St. Lucie Units 1 and 2  
Docket Nos. 50-335 and 50-389

Florida Power & Light (FPL)/St. Lucie's Third Overall Integrated Plan Status Report in Response to March 12, 2012 Commission Order Modifying Licenses with Regard to Requirements for Mitigation Strategies for Beyond-Design-Basis External Events (Order Number EA-12-049)

Third Six Month Status Report for the Implementation of Order EA-12-049, Order Modifying Licenses with Regard to Requirements for Mitigation Strategies for Beyond-Design-Basis External Events

Figure 1 PSL FLEX Electrical Connections (Unit 1) (Rev 0A)

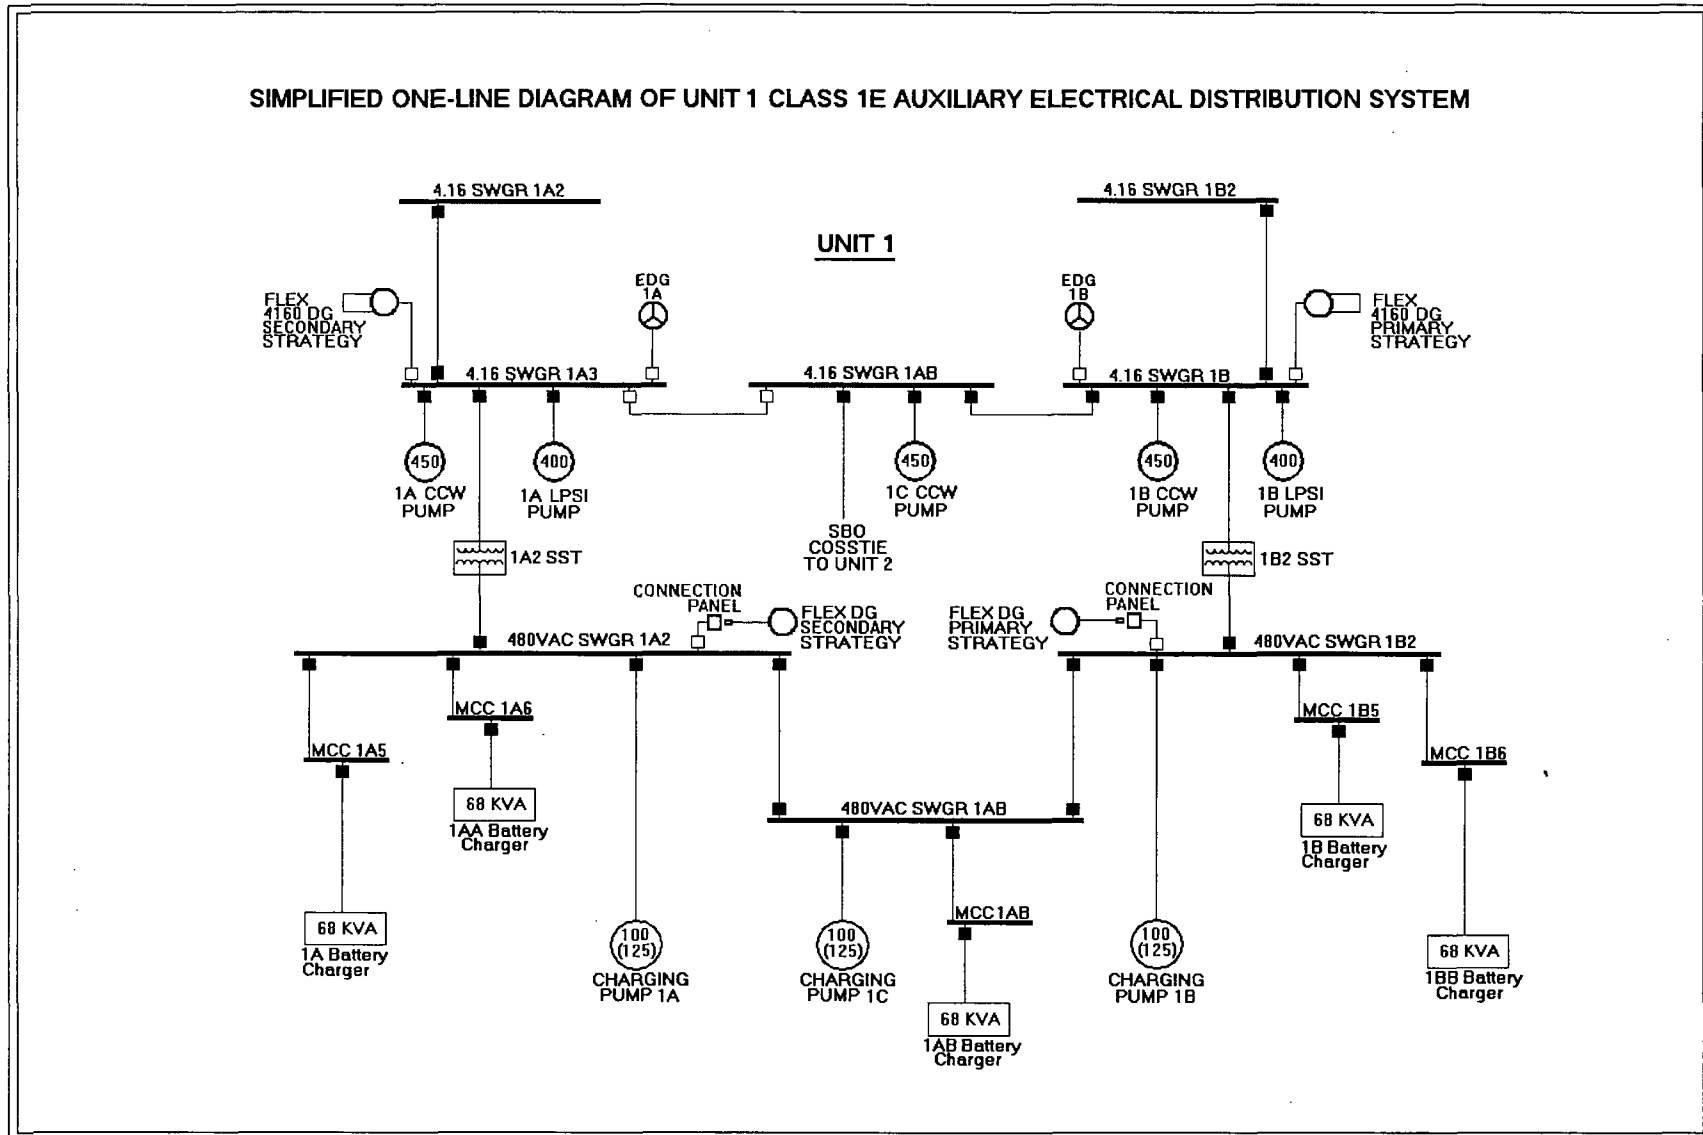
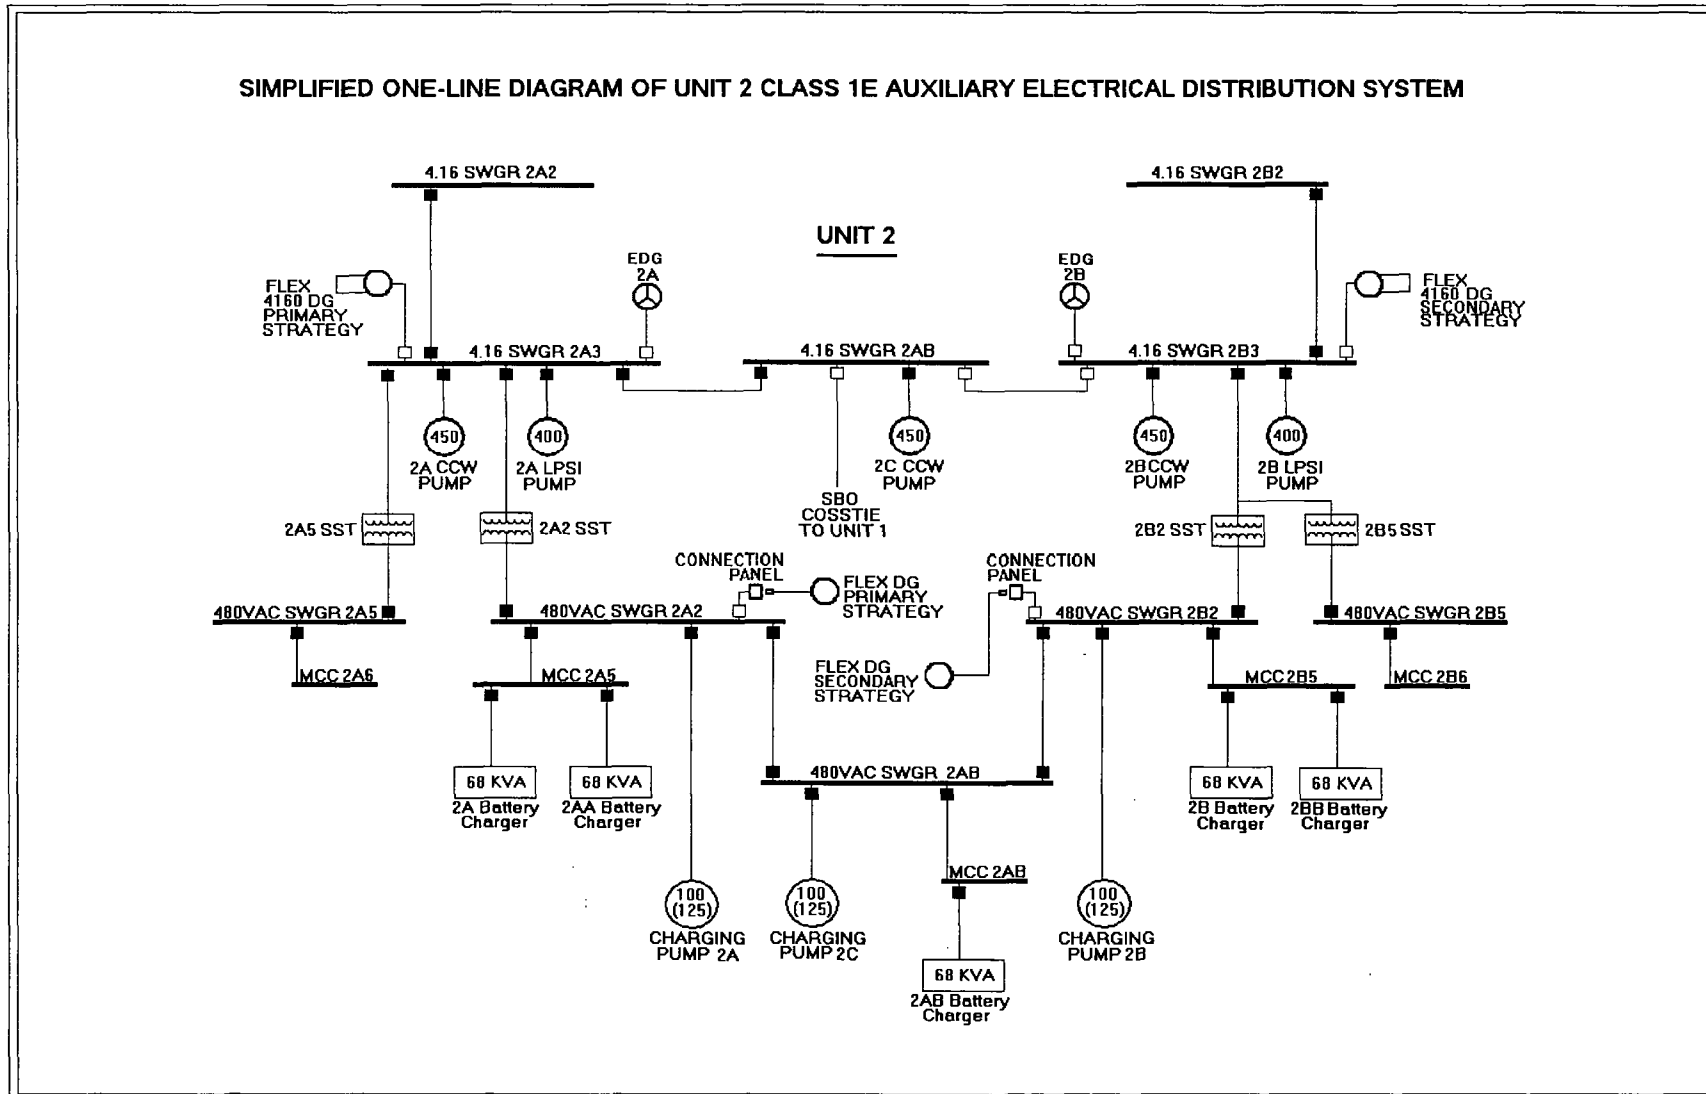
The St. Lucie FLEX strategy for making electrical system connections has evolved from that indicated in the Reference 1 response figures to be consistent with NEI 12-06 guidance (Reference 4). Refer to attached revised electrical connection figures; final versions will be provided in a future six-month update. Note the 480 volt connections will now be made using procedurally controlled breakers rather than using transfer switches.

Figure 11 Connections for CST FLEX Pump Suction on CSTs (Rev 1)

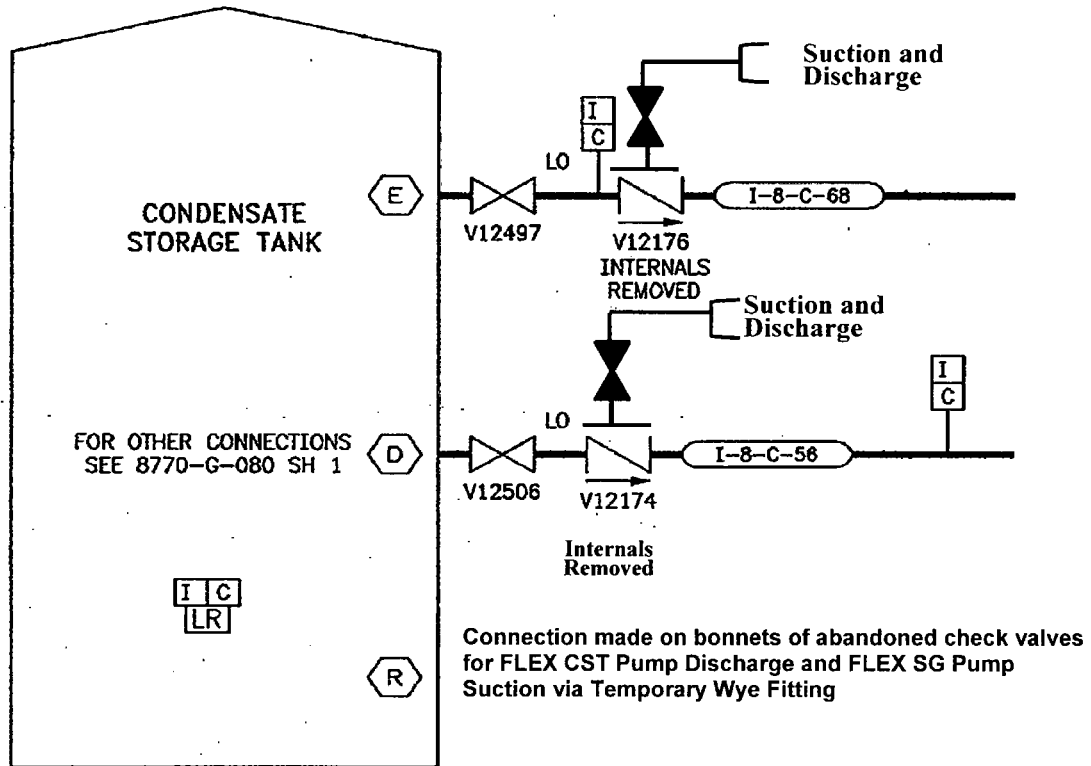
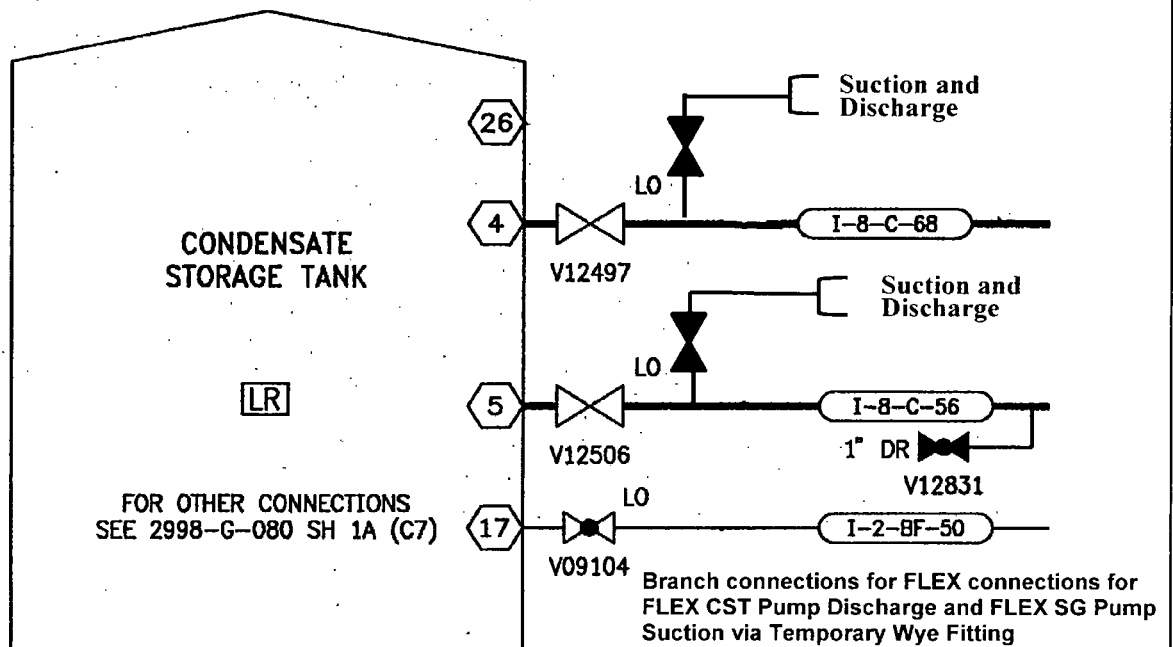
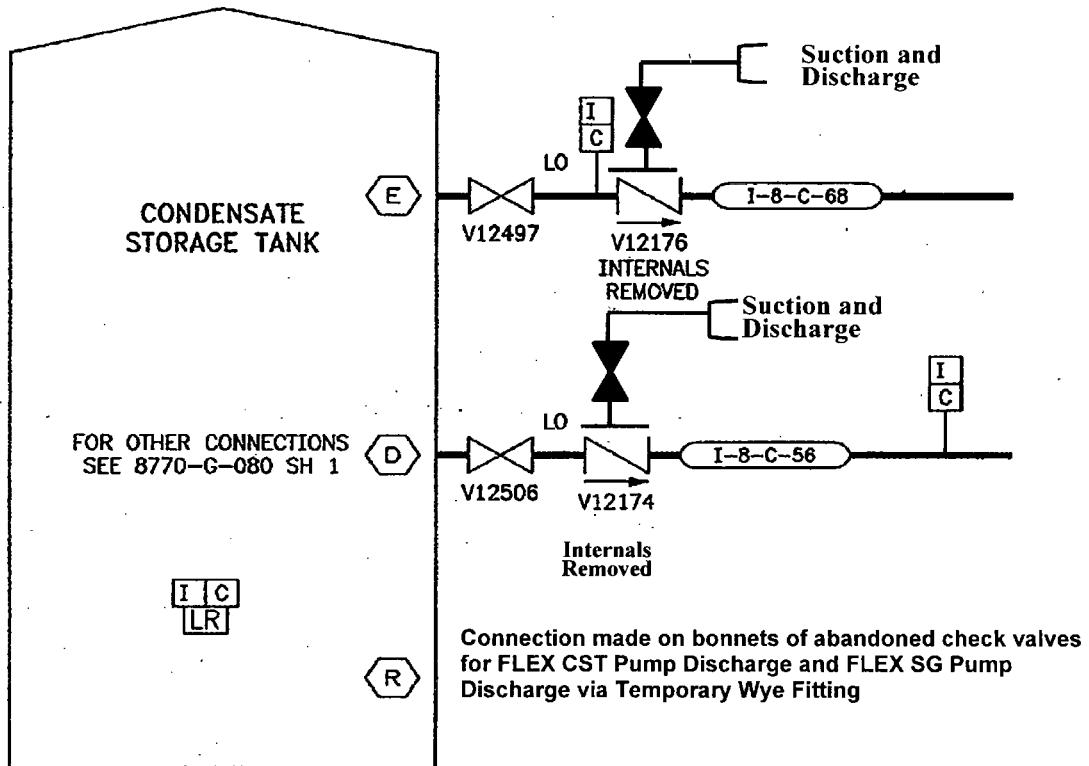
The St. Lucie FLEX strategy for making mechanical system connections has evolved from that indicated in Reference 1 response figures to be consistent with NEI 12-06 guidance (Reference 4). Secondary connections may require reconfiguration (e.g., removal of valve bonnet or disassembly of a flanged pipe joint) if validated that time and resources are reasonably available to support the reconfiguration. Location of the connection points provide reasonable assurance that at least one connection will be available for all applicable hazards. Refer to attached revised mechanical connection Figures 11, 12 and 14 for the latest changes.

Figure 13 Connections for SG FLEX Pump Discharge to AFW Pump Discharge Lines (Rev 0A)

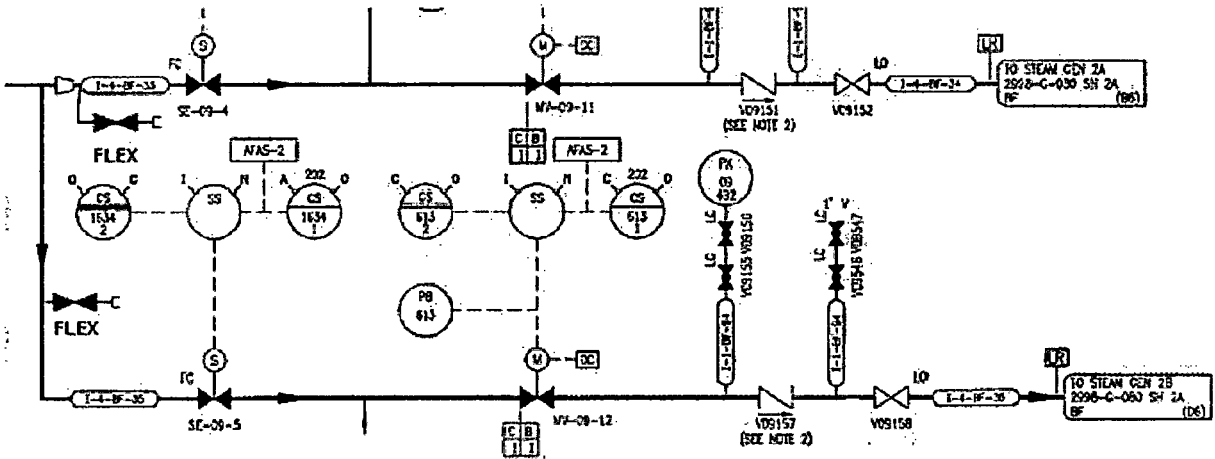
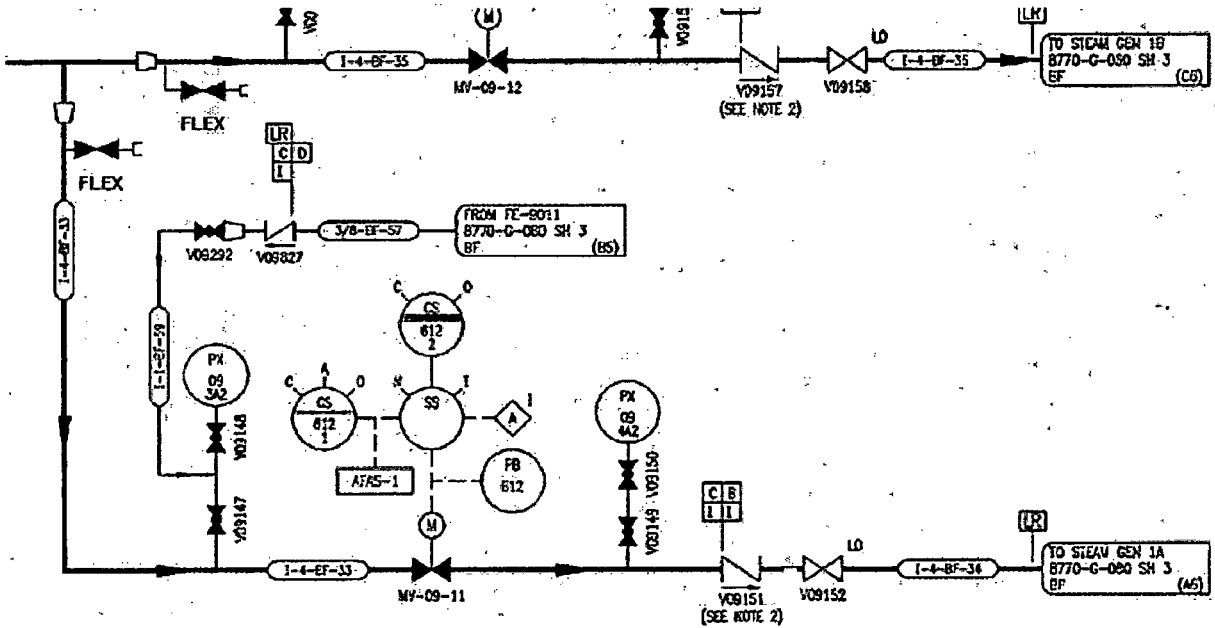
Install a 4" isolation valve and hose connection to the AFW pump 1C(2C) discharge piping for Steam Generator Injection by using a FLEX pump.

Figure 14 Connections for SG FLEX Pump Discharge to LPSI Pump Discharge Lines (Rev 1)

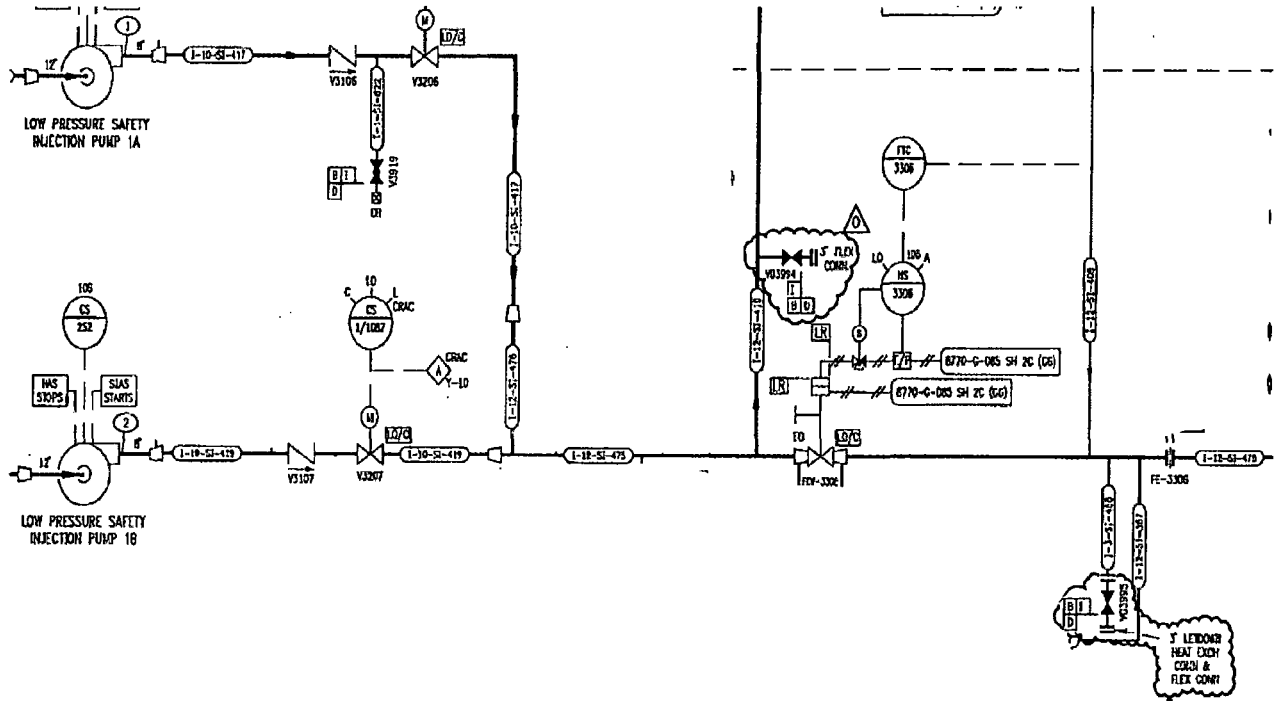
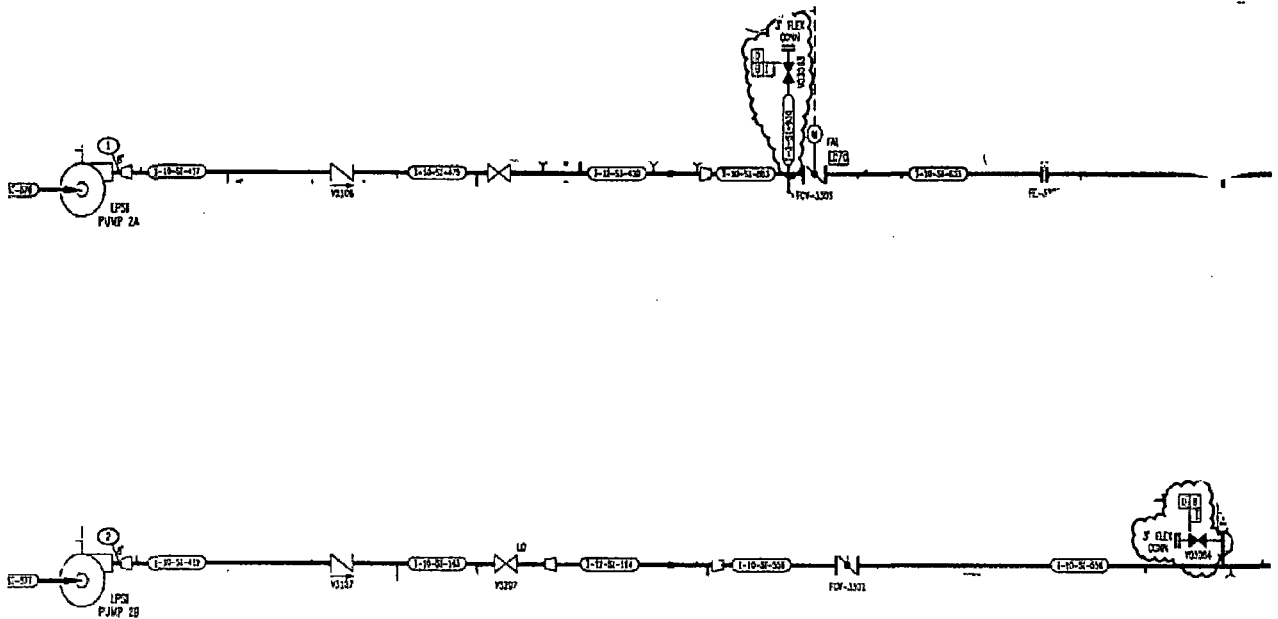
Install primary and secondary 3" isolation valves & hose connections on the LPSI 1A/1B Pumps common discharge piping. For RCS cold leg injection with FLEX SG Pump drawing suction from the RWT.

Install 3" isolation valves and hose connections on each of the LPSI 2A & 2B Pumps discharge piping. For RCS cold leg injection with FLEX SG Pump drawing suction from the RWT.

Figure 22 Connection for SFP FLEX Pump Discharge to Fuel Pool Pump (Unit 1, Unit 2 Similar) (Rev 0)

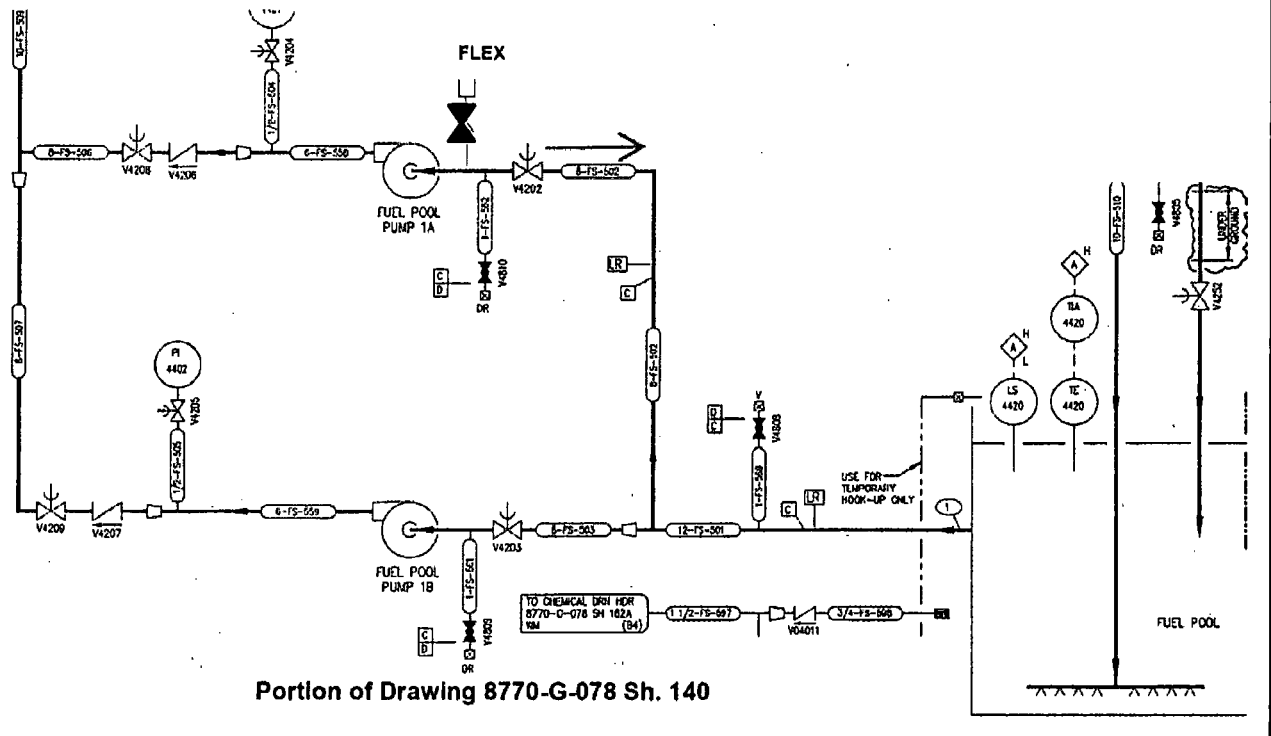
The Reference 1 FLEX response described the hardened makeup flowpath to Maintain Spent Fuel Pool Cooling as via the 2½" ICW lines on the exterior east wall of each Fuel Handling Building (FHB). In lieu of providing missile protection for these lines, an alternate missile protected flow path will be provided. The alternate path is via a new FLEX connection on the suction of one of Spent Fuel Pool Pumps on each unit. These lines and their flow paths to the Spent Fuel Pools are within the missile protected interior of the FHB's. The 2½" ICW lines remain the preferred hardpipe flowpath should they remain intact following the BDBEE. See new Figure 22.

Install a 3" isolation valve and hose connection on SFP Pumps 1A & 2A Suction piping. For SFP Hardened Makeup from FLEX SFP Pump
